Independent Peer Review of Engineering Advice - Grenfell Tower for MHCLG

Dr J M Roberts FREng BEng PhD FICE FStructE

Senior Director of Structural Engineering, Jacobs UK Limited

Figure 3. Floor plan layouts showing the structural supports (walls and “diamond shape” columns)

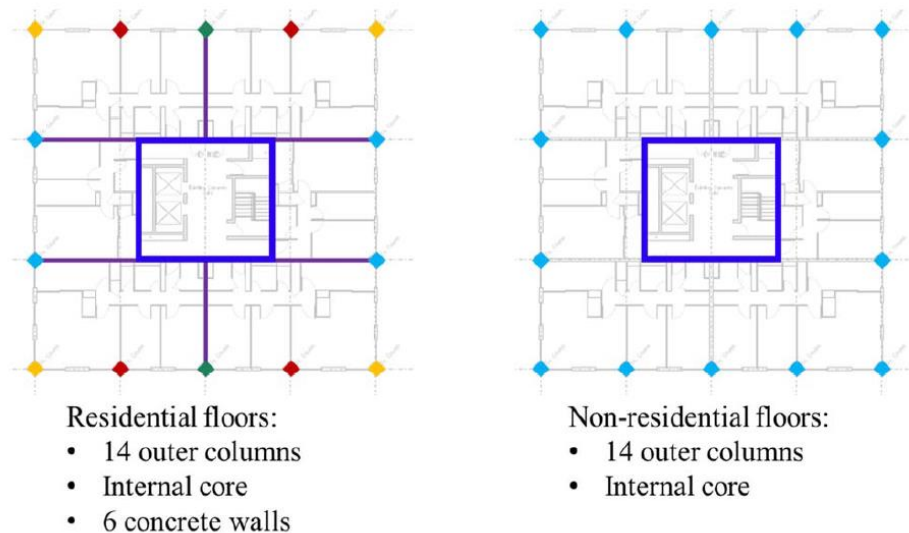
- 24 Figure 3 from the report provides a useful summary of the column locations for the upper storeys (“residential”) and lower stories (“non-residential”) and I have already reproduced it here as Figure 3 (above) and this is repeated for convenience below:-

- 25 The regular layout, with a central core (the dark blue “box” formed from 4 walls), 14 external columns, and (on the residential floors only) the 6 internal party walls (purple/grey colour) provides a straightforward structural layout and allows a reasonably simple assessment to be made of the structural behaviour.

Figure 4. Example from Atkins February 2020 visual survey

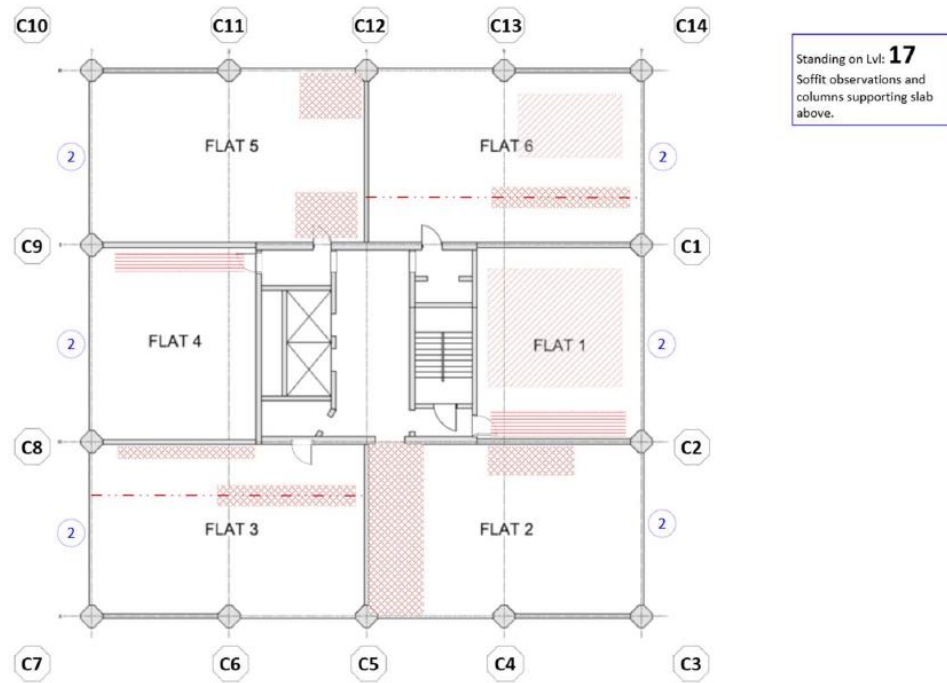
77 As can be seen from the above example, the Atkins visual survey provides a more specific record of exactly where the damage on any particular floor occurs, as compared to the overall single classification of damage that has been used by RSK. Then, in Section 5.2.2. of the report Atkins explain that each individual damage zone can be associated with a group of elements from the standard “floorplate finite element mesh” which they show at their Figure 5.3.

Figure 5. Stability system (above Level 4)

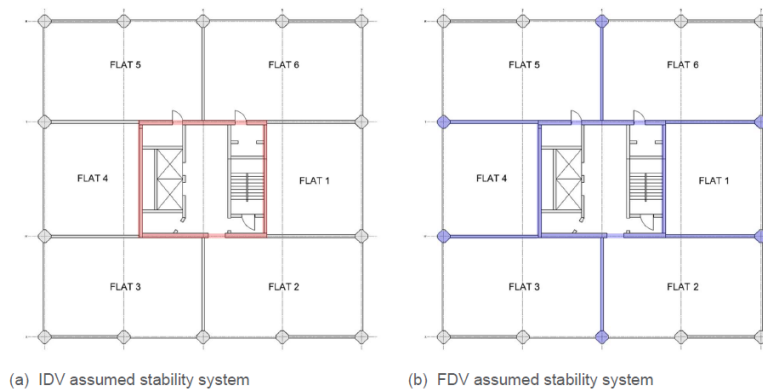
- 81 In my opinion the FDV model as shown on the right-hand side is correct, and, as such, should give a much “less conservative” result than the IDV⁵⁴ model shown on the left-hand side. It is important to note that the contribution of the concrete party walls to the global stability of the building is dependent largely on the effectiveness of the 6 columns⁵⁵ on the external perimeter below level 4. Atkins do not actually give any quantitative value for this increase in lateral stability – they merely state (correctly) that since the model assumed for the IDV assessment was shown to be satisfactory, then the model used for the FDV must obviously be satisfactory “by inspection”.
